CONSTRUCTION ADDENDUM: 1

PROJECT NAME: 600 Building Lobby TI**PROJECT MANAGER:** Amy Kurtz**PHONE NUMBER:** 206-574-1283**EMAIL ADDRESS:** AmyK@kcha.org

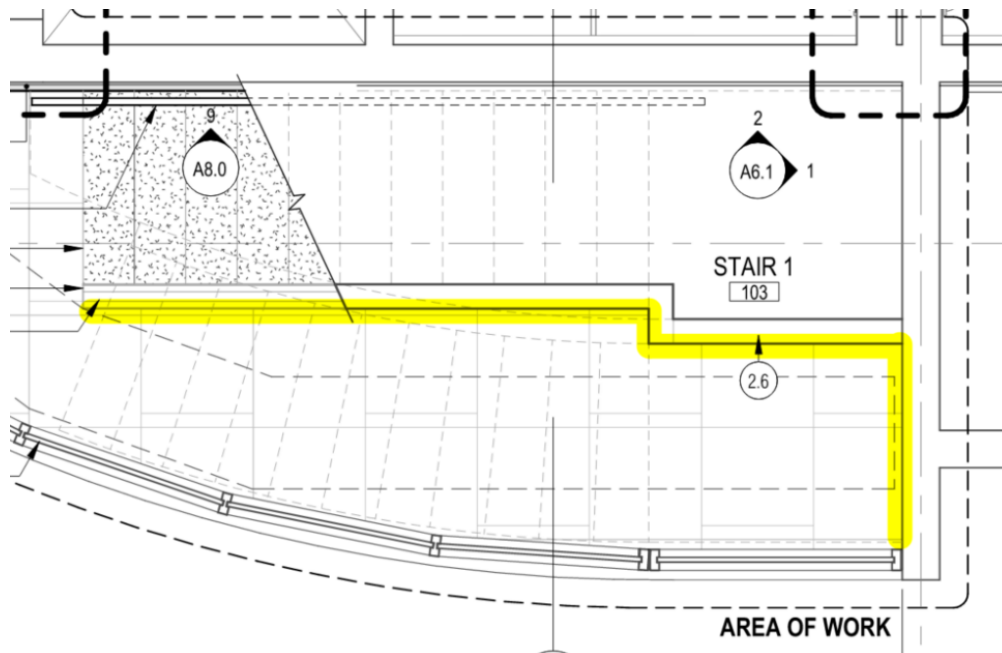
1. Could you please clarify what should be used as the base at the bottom of the stair on Level 1? Area highlighted below.

ANSWER: Terrazzo Base (TER.B-1)
